The State of New Hampshire
DEPARTMENT OF ENVIRONMENTAL SERVICES

July 25, 2019
Letter of Deficiency
DSP #19-016

RE: Pickpocket Dam #D029007, Brentwood

B

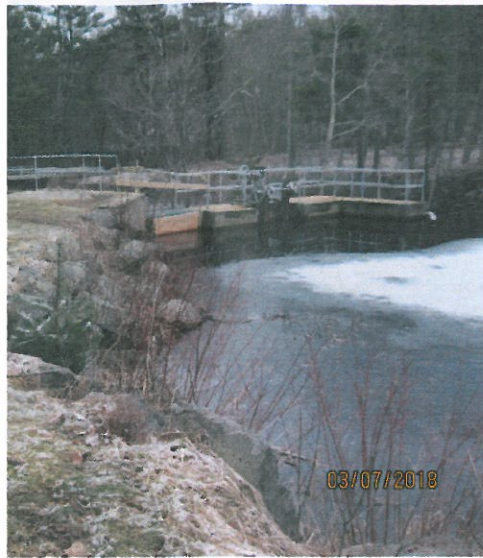
4. Remove the trees and brush from the crest, upstream and downstream portions of the embankment, within 15 feet of the spillway abutment walls and within 15 feet of the toe of the embankments. (Photos: B - E, G - N).
